Nez Perce

October 25, 1995

The Nez Perce Tribe Department of Environmental Restoration and Waste Management (ERWM) has received and reviewed a copy of **Description of Work and Sampling and Analysis Plan for Pore water sampling at Groundwater-River Interface Adjacent to 100-D, -K, and -H Reactor Areas, BHI-00620, Draft A**. Enclosed, for your consideration, are the ERWM's specific comments and suggestions on that document. 42325

Figure 2. Chromium Distribution in the Hanford Site Unconfined Aquifer of the 100-D and 100-H Areas. Data shown is total chromium concentration values in ppb for filtered groundwater samples collected in October of 1992.

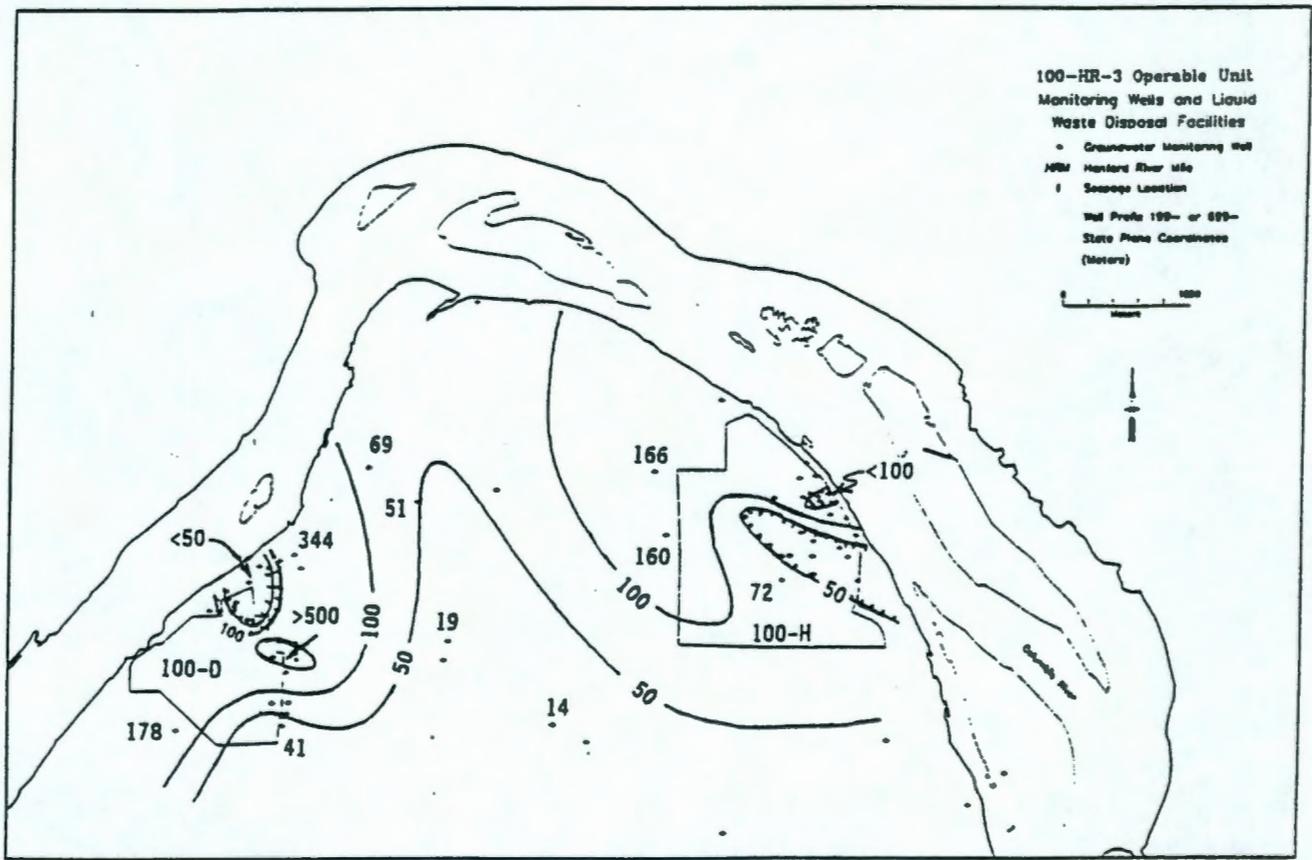
- a. In the 100-D area, the proposed sampled area should be expanded to the Northeast by approximately 3500 feet to coincide with the 100 $\mu\text{g/l}$ chromium contour shown in Figure 2 (map attached) of **Speciation and Transport Characteristics of Chromium in the 100D/H Areas of the Hanford Site, WHC-SD-EN-TI-302**, by E.C. Thornton, J.E. Amonette, J.A. Olivier, and D.L. Haung, dated 7-6-95. ⁴²⁰⁰⁵

- b. In the 100-H area, the proposed sampled area should be expanded to the Northwest by approximately 4000 feet to coincide with the 100 $\mu\text{g/l}$ chromium contour shown in Figure 2 of **Speciation and Transport Characteristics of Chromium in the 100D/H Areas of the Hanford Site, WHC-SD-EN-TI-302**.
